CERTIFICATE OF APPROPRIATENESS

Property: 1113 W Cottage Street, Lot 17, Block 128, North Norhill Subdivision. The property includes a historic 1,182 square foot, one-story wood frame single-family residence and a detached garage situated on a 5,000 square foot (50' x 100') interior lot.

Proposal: Alteration – Remove and replace the existing original multi-lite front door with a wood door with upper lites.

PROPOSED DOOR

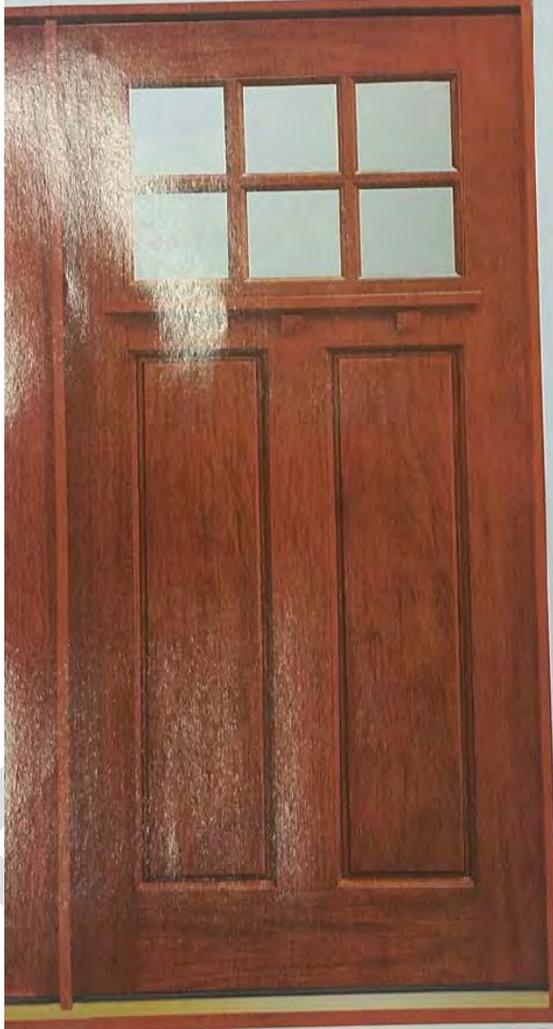
<i>The front door is a highly visible aspect of a residence's historic character. Replacing an original door with a door of a different style and appearance alters this character significantly and is not appropriate.</i> |

<i>Replacing the original front door with an inappropriate Craftsman-style door does not preserve the building's character.</i> |

<i>The original front door is characteristic of cottage-style residences. The proposed replacement door is of a different, incompatible style.</i> |

<i>The front door constitutes significant historic material and should not be removed unless damaged beyond repair. Existing damage is limited to glass lites which can be replaced. Additional damage can be pre-empted by installing a grill or panel on the interior of the door. The proposed Craftsman-style replacement door is not appropriate for a cottage.</i> |
